SAFETY DEFECT BULLETIN

Subject: KZRV, L.P., Travel Trailers Equipped With Dimplex Fireplaces Model #BF6000

How to identify recalled plug-in remote control receivers:

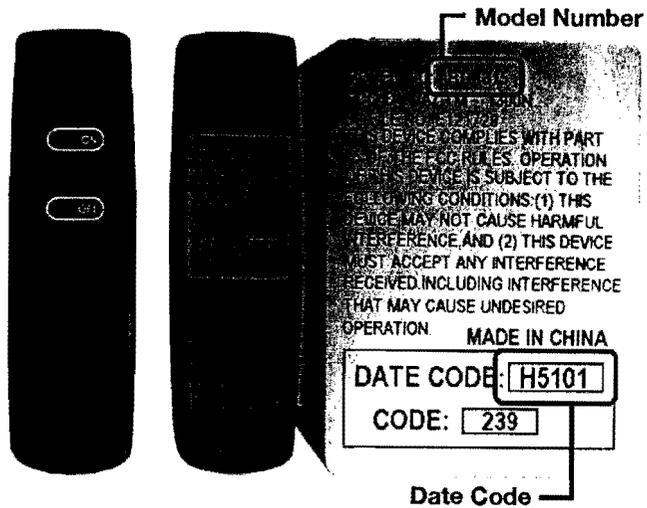
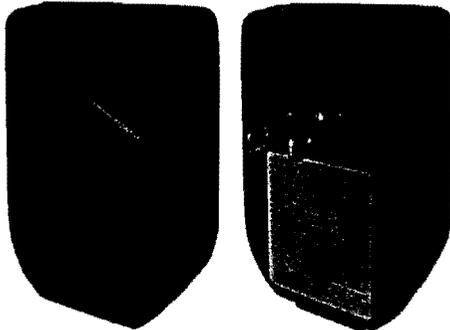
This style of recalled plug-in receivers have Model Numbers 47-1001 and 47-1010-R or DOC ID # 255K656-61-8367R

This style of recalled plug-in receiver has Model Number APT-1315

Please refer to the attached "*Remote Control Replacement Instructions for BF6000, BF6000*, DF2603, and NNF5500*". Total time allowance for a remote control receiver and subsequent remote control receiver installation will be 1.5 hours. All parts and the labor to inspect and install them will be at no charge to the consumer. All defective remote control receivers may be disposed of in accordance with applicable law and need not be returned to KZRV, L.P., or Dimplex. Upon receipt of the claim form you will be reimbursed for the appropriate time listed above at your standard rate.

Remote Control Replacement Instructions For BF6000, BF6000*, DF2603, NNF5500

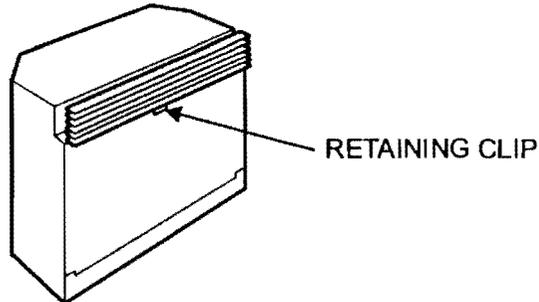
- a) Remove retaining clip using a slot screwdriver

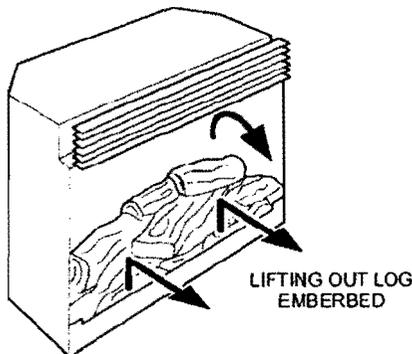
- b) Remove glass

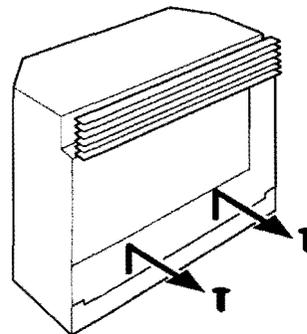
- c) Remove log set
